Subject: File # CAO19-015 Comments

I wish to comment on File # CAO19-015/ Permit Type III.

Approximate area of steep slope where ecology blocks are proposed, looking east:

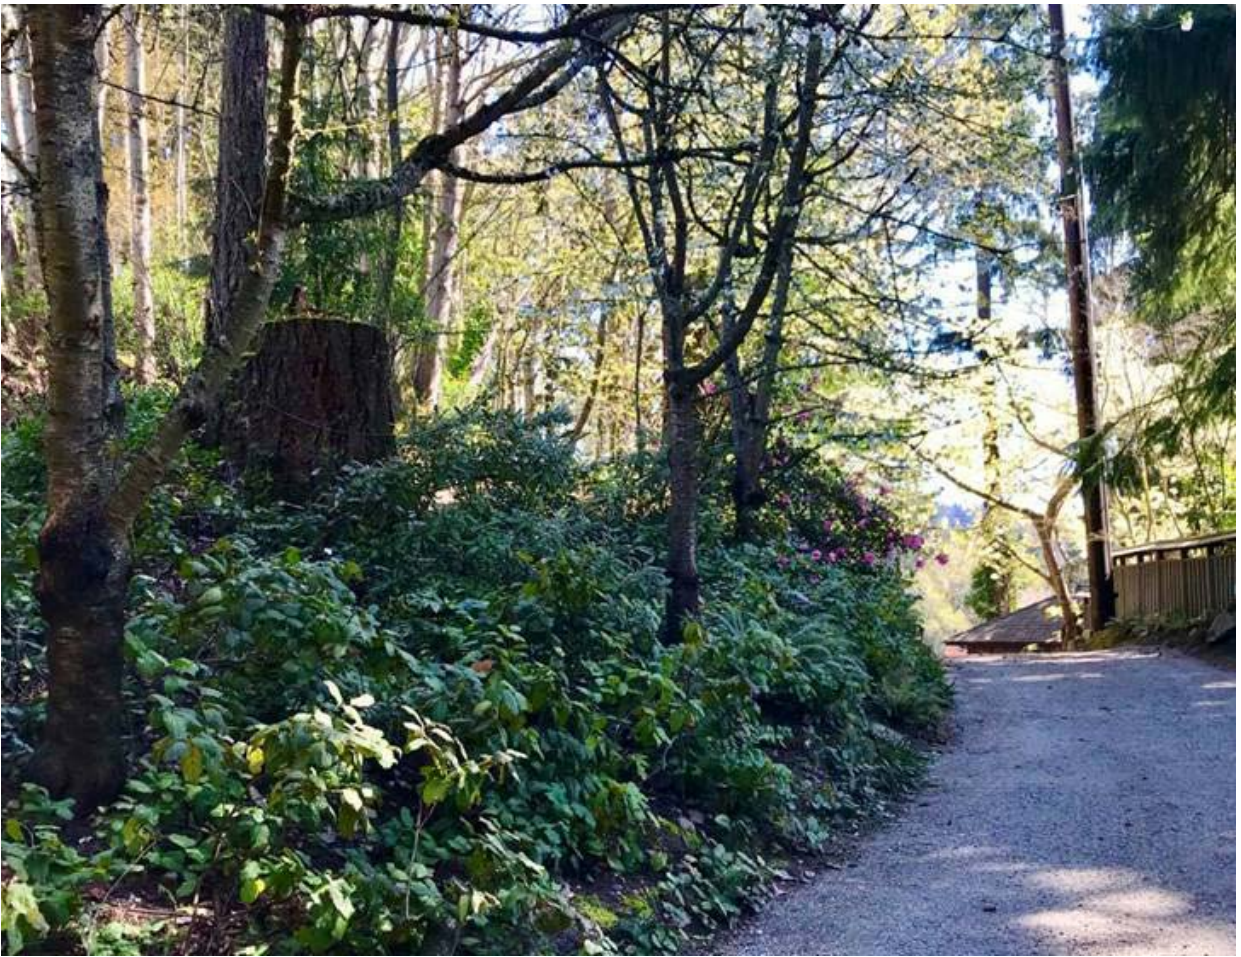
There is an apparent Ecology concrete wall proposed on the upslope side of the development to intercept offsite drainage. Ecology blocks are typically 2' x 2' x 6' eyesores. The placement of these blocks appears to be along a steep slope (identifying the planned location at the site is not clear with the inaccuracies in references like the rockery and the lack of a clear property line). Founding an ecology block on a steep slope is at best risky and at worst will result in failure (settling and tipping) over time, well after the developer is no longer available for corrective measures. It will require significant excavation into the steep slope to a depth likely to impact the roots of trees it is shown upslope of, resulting in stress on those trees, which are valuable to the neighborhood. It also appears that the block wall would require removal of several 8 – 10 inch shading maple trees. Use of ecology blocks in this setting should be scrutinized for all of these reasons. I included two pictures showing the steep slope where ecology blocks are proposed below.
